Staff Report – Agenda Item 4 Oakland Roots and Soul Sports Club Interim Facility Compatibility Determination September 16, 2026

RESOLUTION 2026-03 – AT REGULAR MEETING SEPTEMBER 16, 2026

Subject: Public Workshop on Proposed Sports Facility (PLN26-0281 – Oakland Roots & Soul Interim Stadium-1150 & 1220 Harbor Bay Parkway, Alameda)

Figure 1. Safety Zones for Oakland San Francisco Bay Airport.

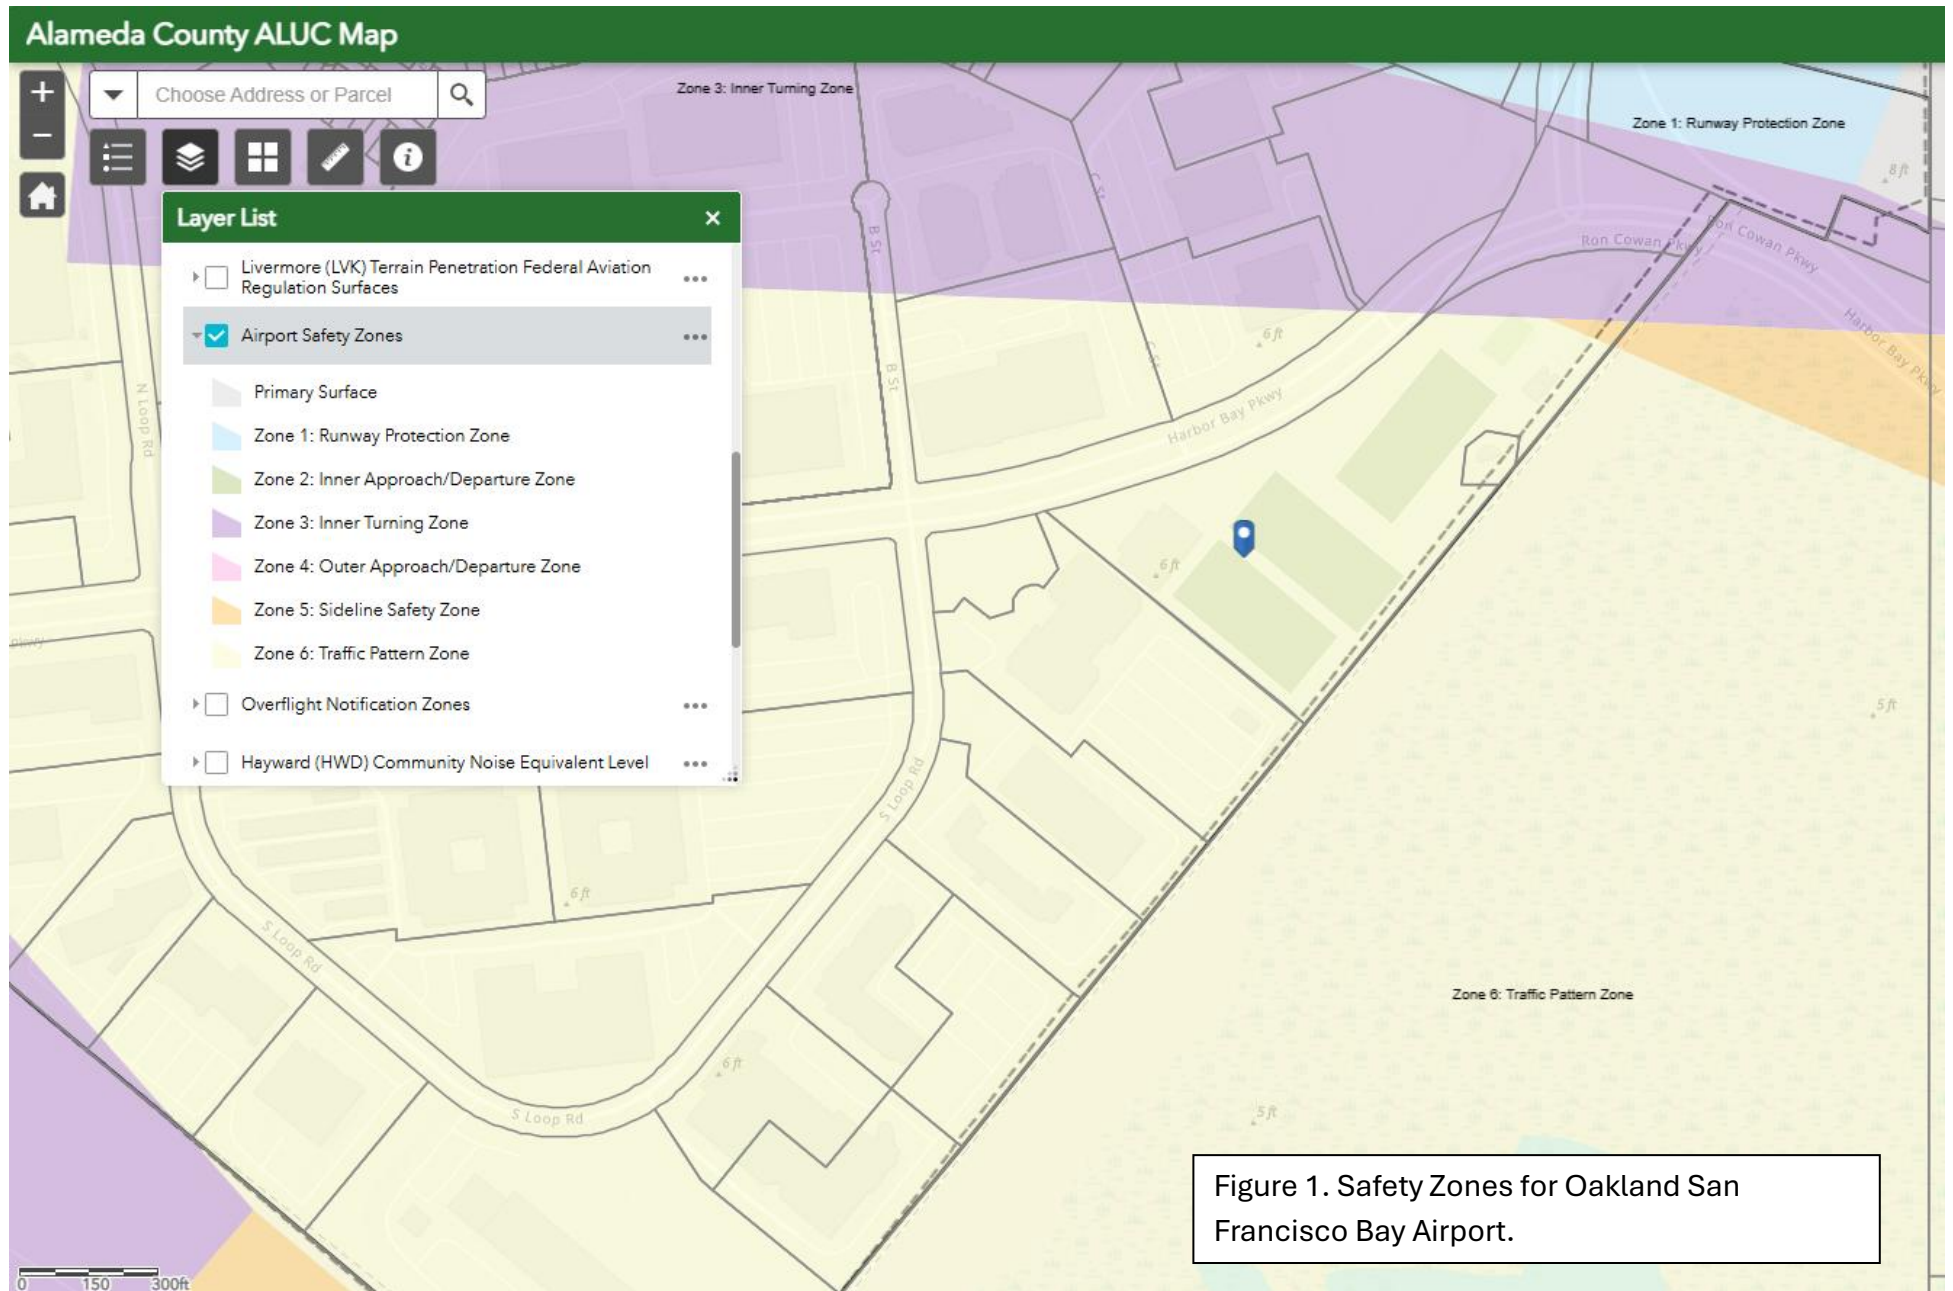
Parcel 74-1339-16 is located in Safety Zone 6, the Traffic Pattern Zone. Parcel 74-1361-8 is primarily located in Safety Zone 6 as well. The northernmost acre of parcel 74-1361-8 is located in Safety Zone 3, the Inner Turning Zone, with a 4,700 foot sliver of Safety Zone 5, the Sideline Zone. As shown in Figure 1 of Attachment A, the proposed improvements occur in Safety Zone 6, so the project will be evaluated with Safety Zone 6 guidelines.

Figure 3. Proposed Improvements, courtesy of Applicant

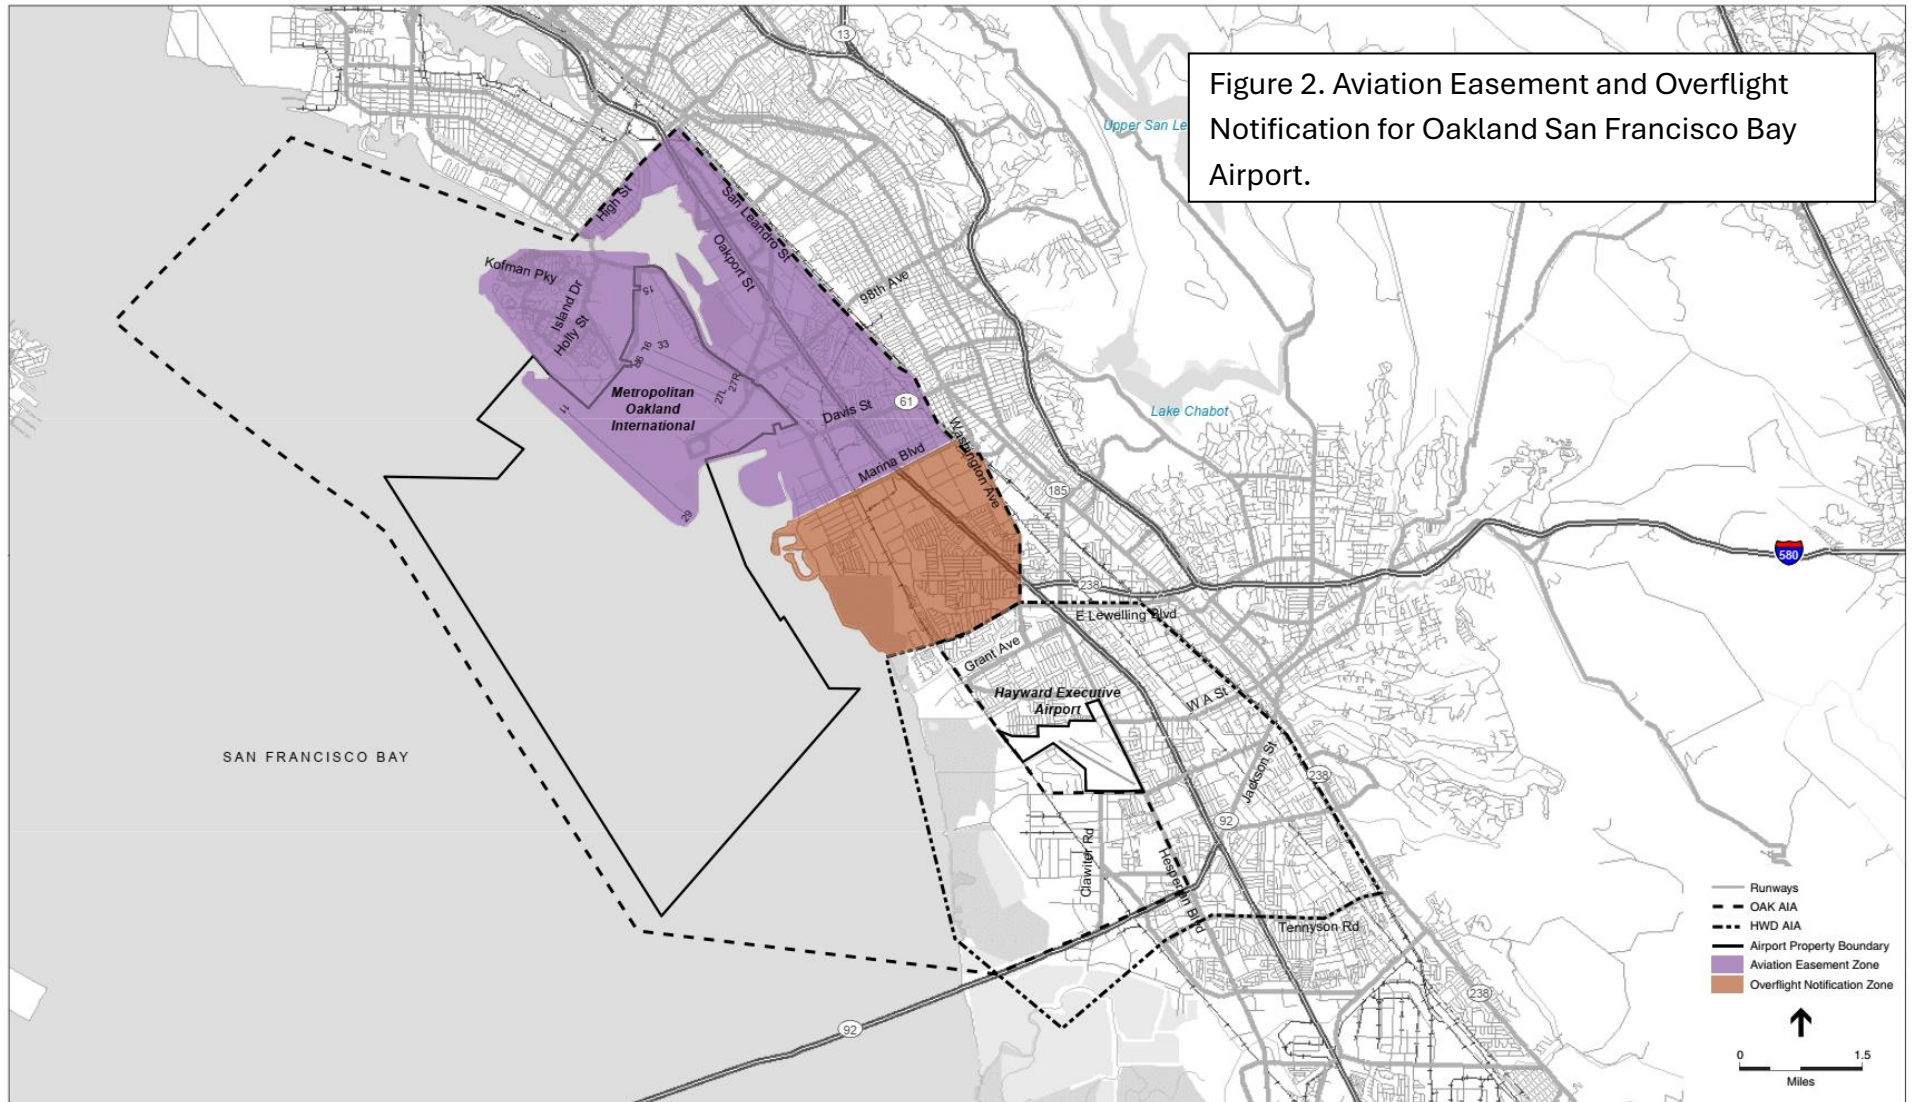
FAA Advisory Circular 70/7460-1N - Obstruction Marking and Lighting notes that red obstruction lights are recommended in urban areas near airports. As depicted in Figure 3 of Attachment A, the six proposed light poles would each have a red light that conforms with FAA requirements. The video score board is planned to be no more than 34 feet above ground level, or less than half the height of the light poles. Renderings provided by the applicant show the scoreboard on the northern side of the proposed interim sports facility facing south.

To minimize any possible lighting confusion, ALUC staff recommend that all outdoor lights be shielded to aim below the horizon. The applicant should work with the Oakland San Francisco Bay Airport to run a flight check at night to ensure the planned lighting would not blind pilots during landings and takeoffs.

Figure 5.
Proposed
lighting
pole,
courtesy of
Applicant.

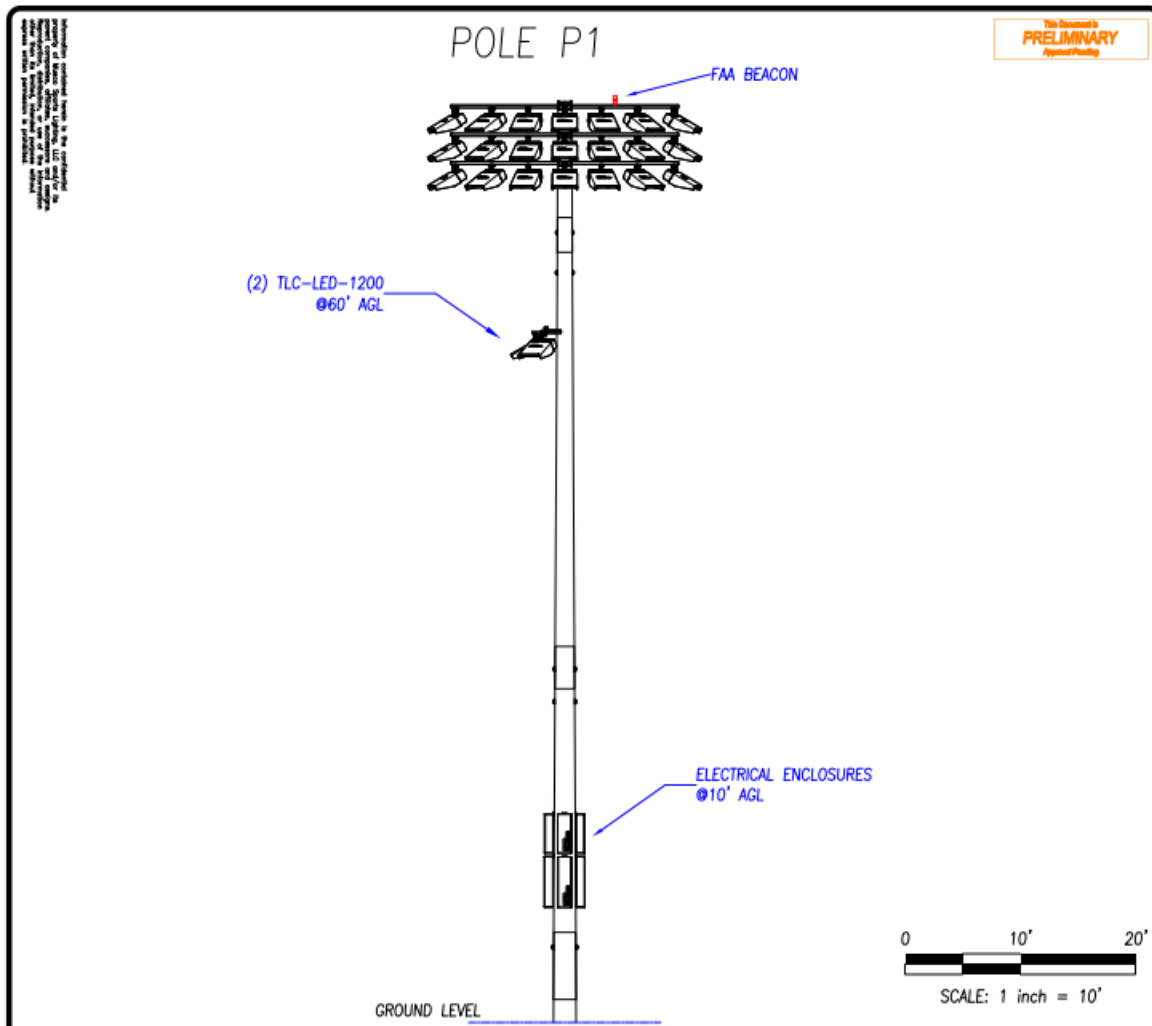
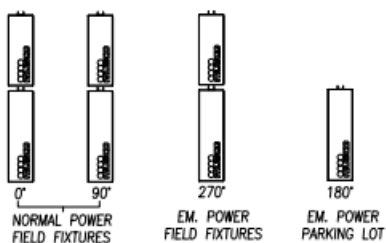
Initial plans indicated that the 6 light poles would be approximately 108 feet in height. Per the August 24, 2026, response from the applicant to the City of Alameda regarding initial comments, the 6 light poles are now designed to be 79.86 feet in height with a tolerance of up to four feet. The FAA beacon and foundation may also add to the total height. An example is included in Attachment A, Figure 5.

WHEREAS, the six light poles proposed by PLN26-0281 are planned to be 79.86 feet in height with a tolerance of up to four feet with a red obstruction light per Federal Aviation Administration ("FAA") recommendations; and
